## Supplier Deviation Disposition Request

PROJECT: Hanford Tank Waste Treatment and Immobilization Plant (WTP Project)

FOR WTP USE			
WTP SDDR No. 24590-WTP-SDDR-MS-17-00118	Rev. N/A	DATE RECEIVED 10/24/2017	
FOR SUPPLIER USE			
SUPPLIER SDDR No. 500005.001-SDDR-03		DATE SUBMITTED 10/23/17	
<b>1. Supplier Name</b> Greenberry Industrial LLC	<b>Address</b> 600 SE Maritime Ave Ste. 190	<b>City &amp; State</b> Vancouver, Wa	<b>Zip</b> 98661
<b>2. Supplier's Order No.</b> 500005.001	<b>3. WTP P.O. or SC</b> 24590-CM-POA-MVSC-00005		10/25/17 JWS Rev 0 - 2
<b>4. Deviation Description</b> (Attach extra sheets, photographs, sketches, etc. as necessary and identify quantity and serial numbers as applicable)			
<ol style="list-style-type: none"> <li>Greenberry Industrial LLC takes exception to the second sentence in section 4.2.2 of the Engineering Specification 24590-BOF-3PS-MVSC-T0002,.</li> <li>Greenberry Industrial LLC takes exception to sections 3.4.2,10.2.9.4 of the Engineering Specification 24590-BOF-3PS-MVSC-T0002,.</li> </ol>

Title of SDDR: EMF Process Vessels - Applying Corrosion/Erosion Allowance to Internal Vessel Components and Design Life Analysis Exception

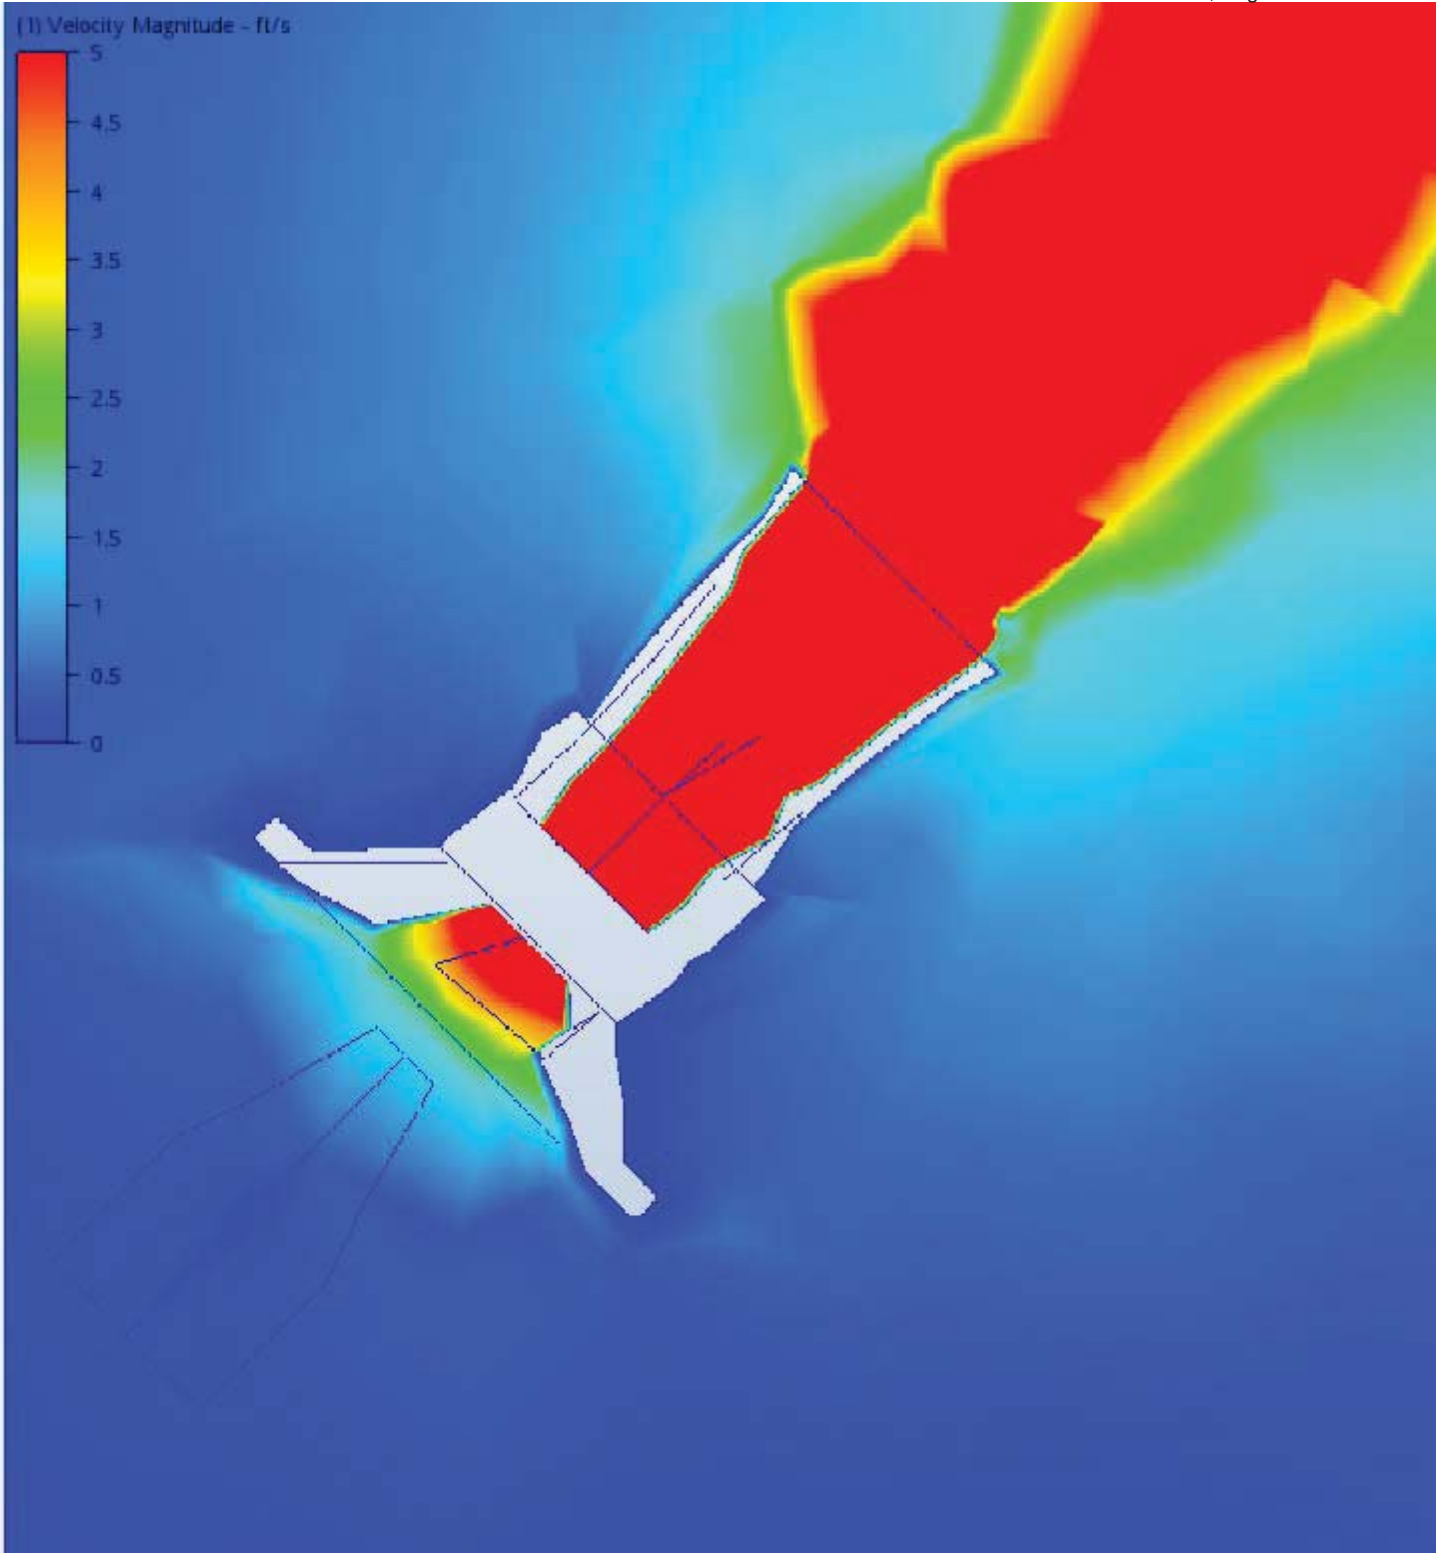
Here are the max velocities at the eductors as requested.

I asked Clarence if they had any test data regarding erosion/ corrosion of this style of eductor to verify the performance with .1" of erosion / corrosion but he said clark-reliance / Jacoby as not performed any of this testing. His opinion was that the unit would perform just fine.

DP-VSL-0003: max velocity at nozzle = 5 ft/s

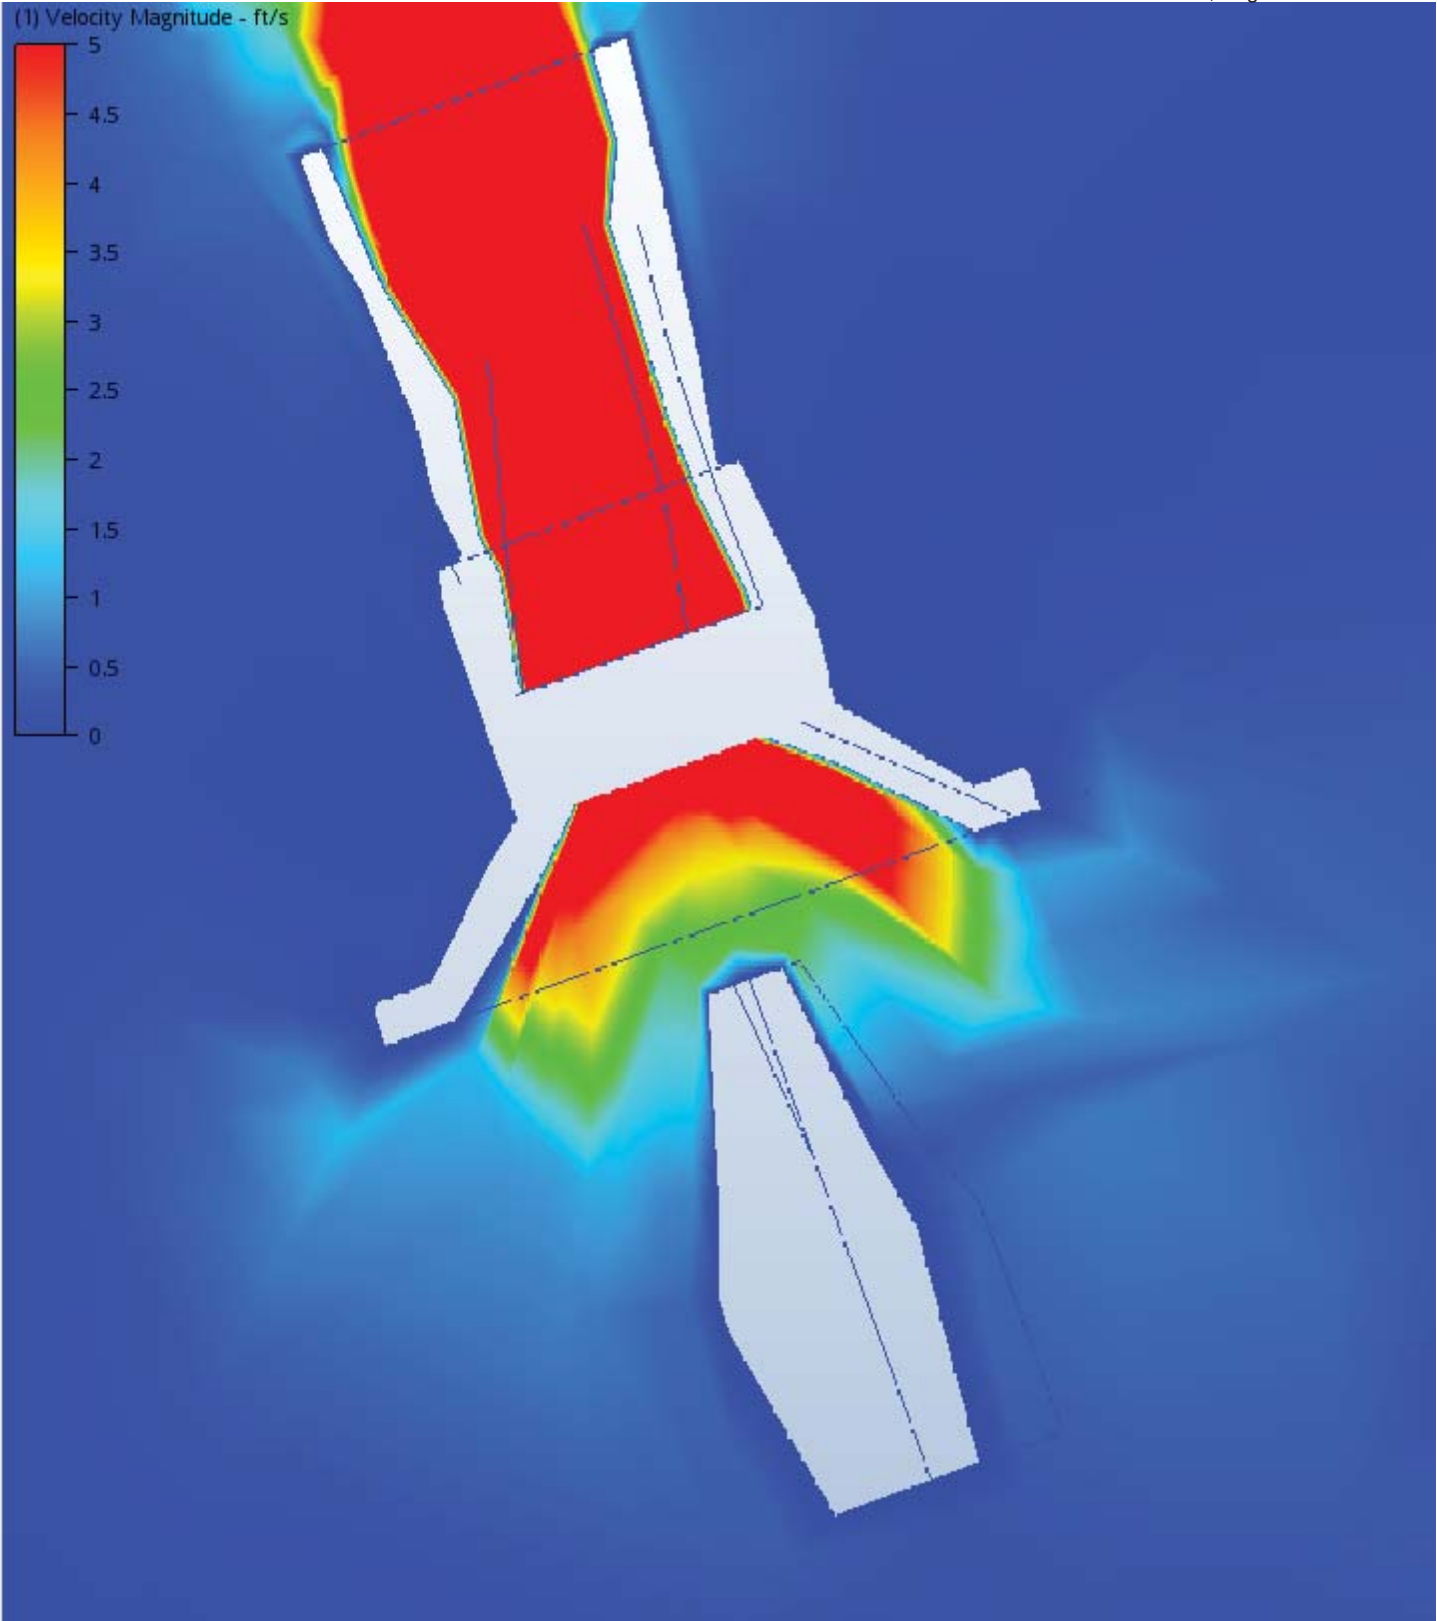
Per your request below are the max velocities at the TLA.

DP-VSL-0002: max velocity at nozzle = 5 ft/s
